EBC Ref: F/25/100141 – Kings Copse Avenue: Transport Assessment Addendum

Ref: OT/ITS19785-019
Date: 12 December 2025

- 1.1 This Transport Assessment Addendum (TAA) has been prepared to address comments raised by Hampshire County Council (HCC) in their response (*ref: 058151*) to the Transport Assessment submitted as part of the full planning application for 192 dwellings on Land South East of Kings Copse Avenue (*ref: F/25/100141*).
- 1.2 The comments raised by HCC are included as **Appendix A** and have been grouped into three categories as follows:
- 1 Vehicle Access
 - 2 Pedestrian and Cycle Access
 - 3 Internal Layout
- 1.3 The TAA responds to queries raised by HCC in turn in each category. It is noted that the response from HCC reviewed and raised no objection to the traffic impact (i.e. trip generation / distribution / junction modelling) of the proposed development and therefore no additional information has been provided regarding this element.

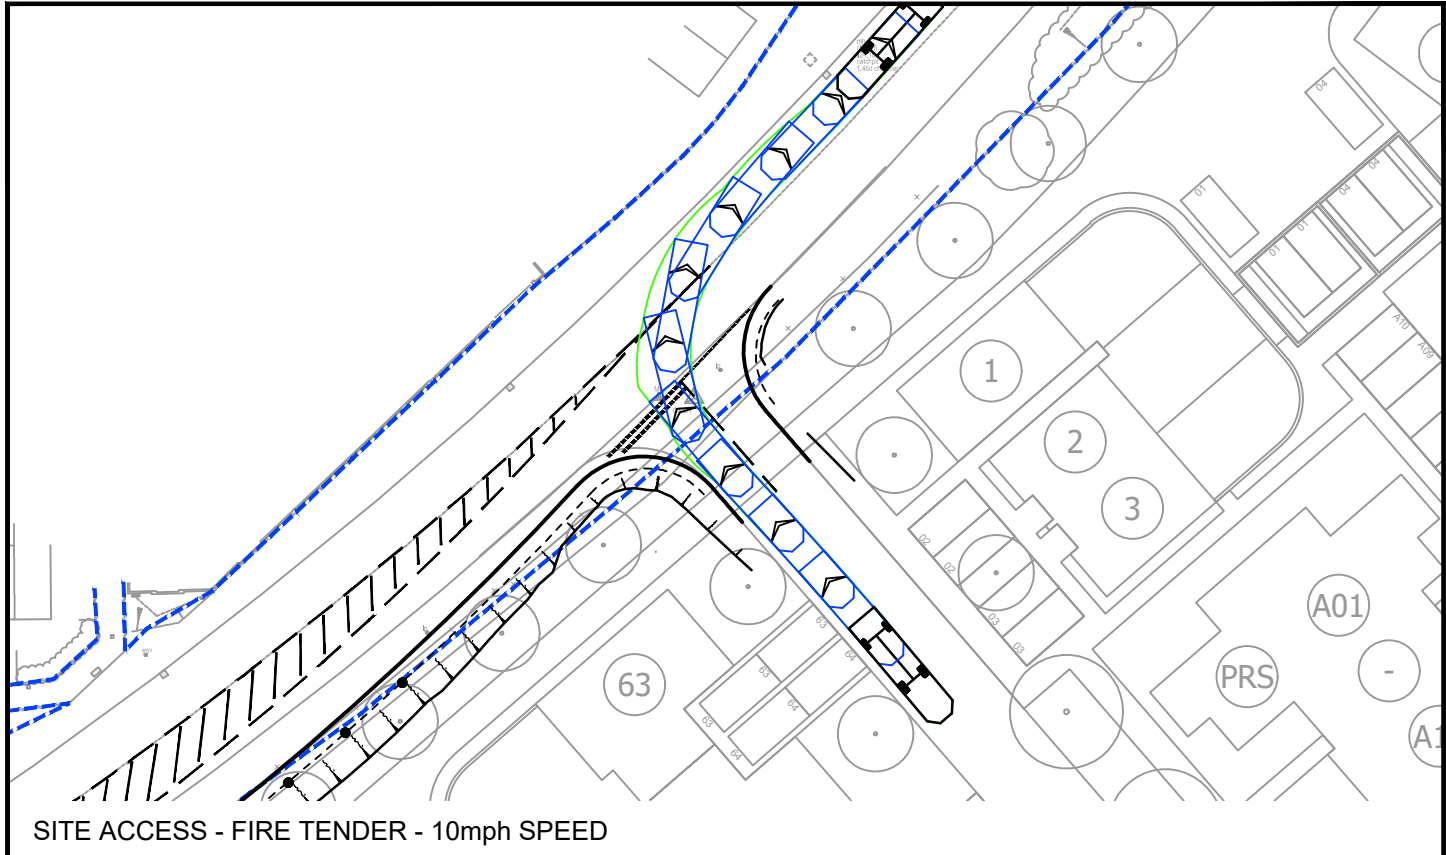
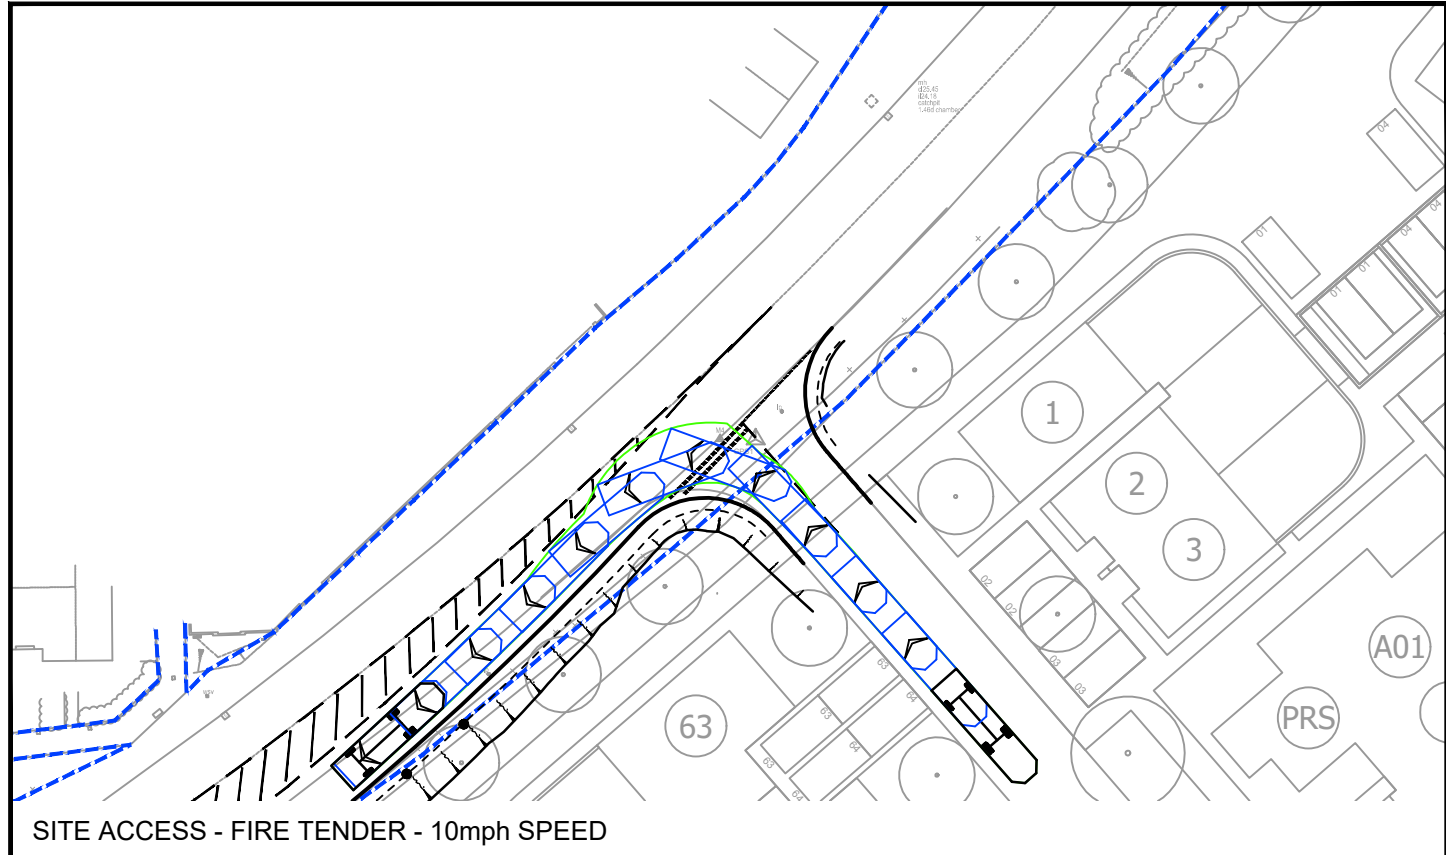
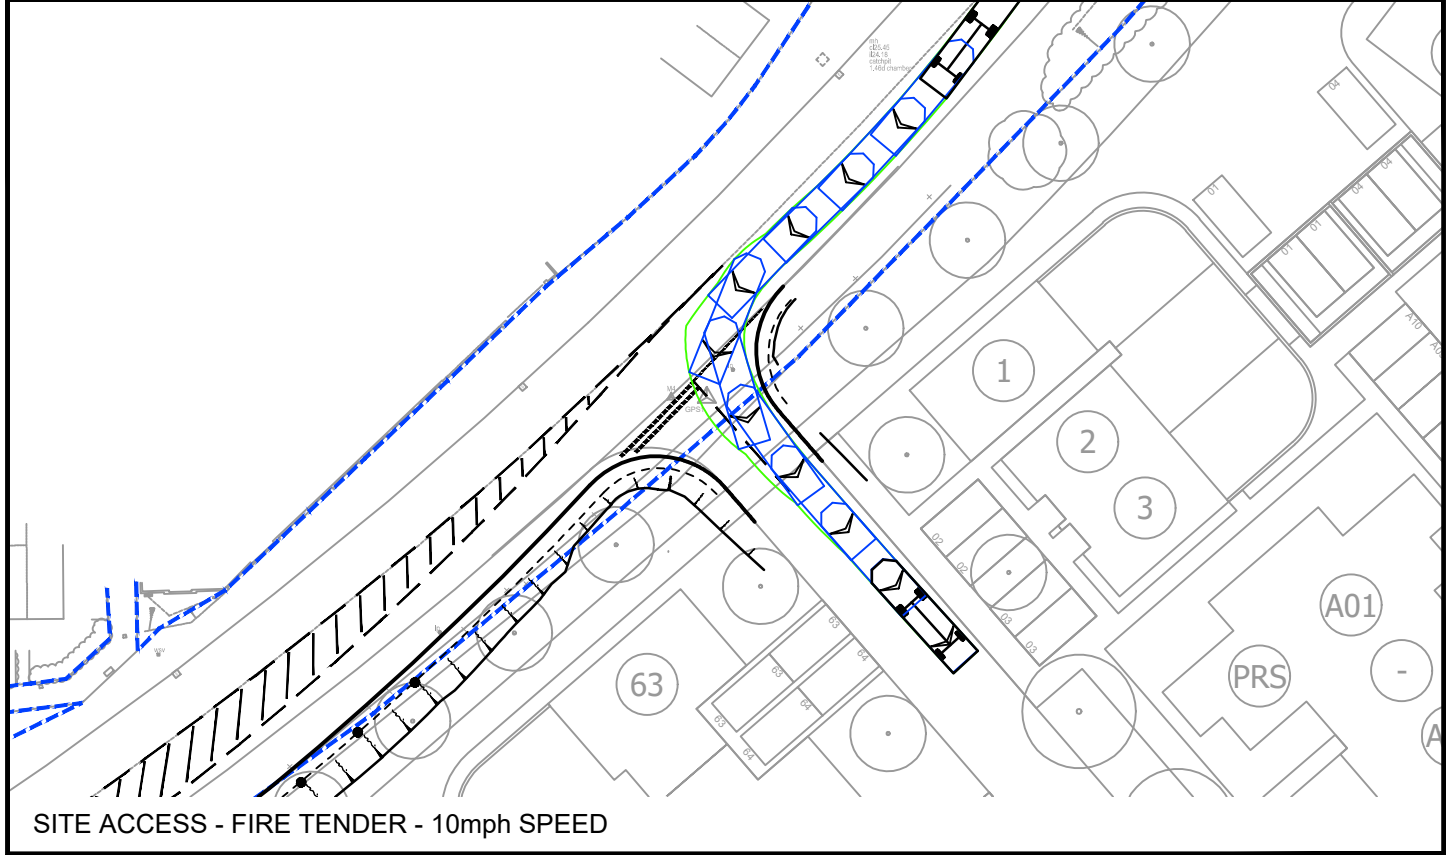
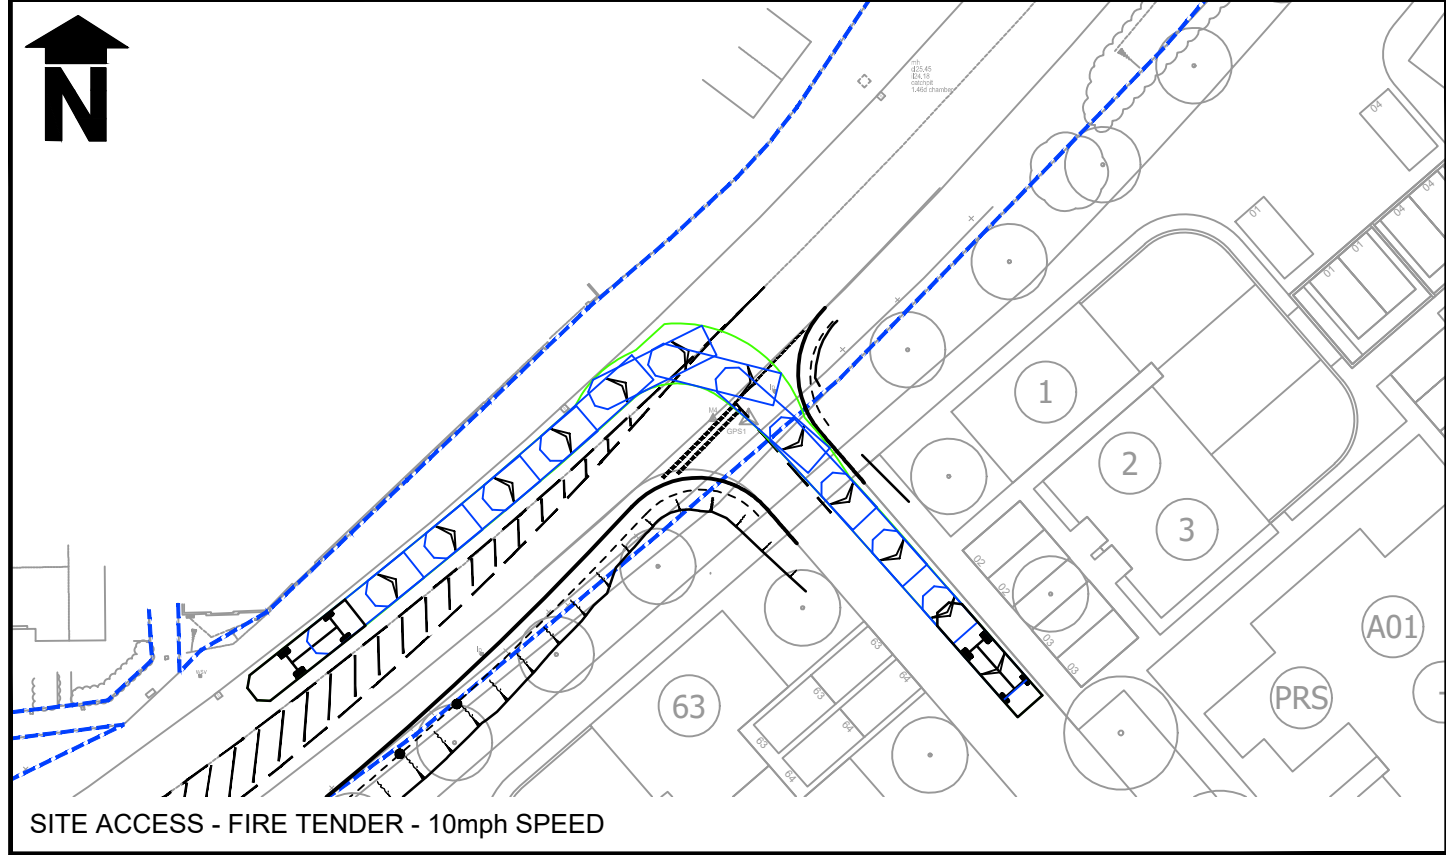
- 2.2.1 HCC have requested that the following swept path analysis scenarios are provided for the proposed access arrangements:

- Fire Tender: Right turn in, right / left turn out.
- Refuse Vehicle: Right / left turn out.
- Large Car: Two-way tracking for all moves.

- Fire Tender: Right turn in, right turn out, and left turn out;
- Refuse Vehicle: Right turn out and left turn out; and
- Large Car: Two-way vehicle tracking for all moves. At present the tracking is shown for internal movements only.

- 2.2.2 The requested swept path analysis scenarios have been undertaken and are illustrated on drawings (ref: 3743.T01 and 3743.T03) included as **Appendix C**. Safe and suitable access to the site will be provided.
